Date Oct 11, 2006	Technical Newsletter	No 24	GRINDEX
Subject New holder for level regulator			www.grindex.com

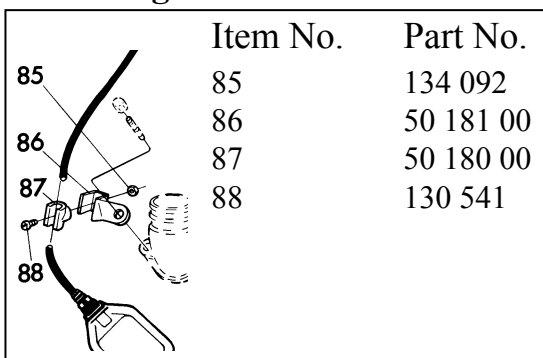
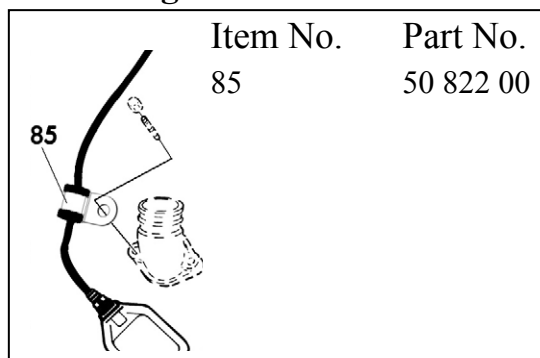
Since end of May 2006, a new holder for the level regulators has been introduced.

The production of holder (item No. 87) has been stopped from supplier.

In the new design one holder replaces item 85, 86, 87 and 88 from the old design shown below. Holder 5018000 (item No. 87) and metal sheet 5018100 (item No. 86) are obsolete. Parts (item No. 85 and 88) will be available as spare parts.
